Access Compliance Report

Public Rights-of-Way

Intersection ID: 10038888	Main Street: STINSON_CT	Cross Street: N/A	Location:	N
ADA ID: 95D038D5137C	Ramp Type: Perp	Initial Pass/Fail: Fail	Overall Compliance: No	Severity Score: 10
Codes/Mitigation Info/Possible Solution		Field Measurements/Component Compliance

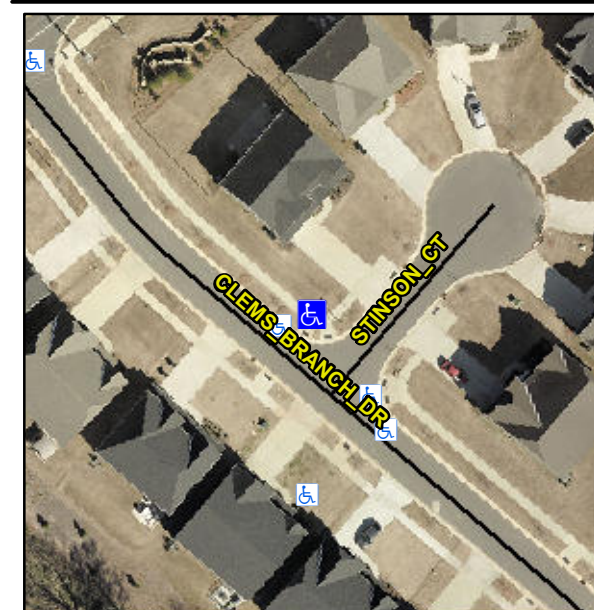
R304.5.1, R304.5.3

Compliance	Description	Data	Compliance	Description	Data
N/A	Ramp Length (in)	100.0	Yes	Ramp Slope (%)	5.5
No	Ramp Width (in)	47.0	No	Ramp XSlope (%)	4.1
N/A	Flare Type LT	N/A	N/A	Flare Type RT	N/A
N/A	Flare Slope LT (%)	N/A	N/A	Flare Slope RT (%)	N/A
N/A	Flare Traversable LT?	N/A	N/A	Flare Traversable RT?	N/A
N/A	Landing Length (in)	N/A	N/A	DWS Provided?	N/A
N/A	Landing Width (in)	N/A	N/A	DWS Contrast?	N/A
N/A	Landing Slope (%)	N/A	N/A	DWS Length (in)	N/A
N/A	Landing X Slope (%)	N/A	N/A	DWS Full Width?	N/A
N/A	Landing Curb? (Y/N)	N/A	N/A	DWS Offset (in)	N/A
N/A	Shared Landing?	N/A			
N/A	Gutter Ponding?	N/A	N/A	Gutter Slope (%)	N/A
N/A	Gutter Lip Ht (in)	N/A	N/A	Gutter X Slope (%)	N/A
N/A	Painted X Walk1?	No	N/A	Painted X Walk2?	N/A
	X Walk 1 Direction	To SE		X Walk 2 Direction	N/A
N/A	X Walk 1 Width (in)	N/A	N/A	X Walk 2 Width (in)	N/A
	X Walk 1 Slope (%)	1.8		X Walk 2 Slope (%)	N/A
	X Walk 1 X Slope (%)	4.6		X Walk 2 X Slope (%)	N/A

Remove & Replace Entire Ramp.
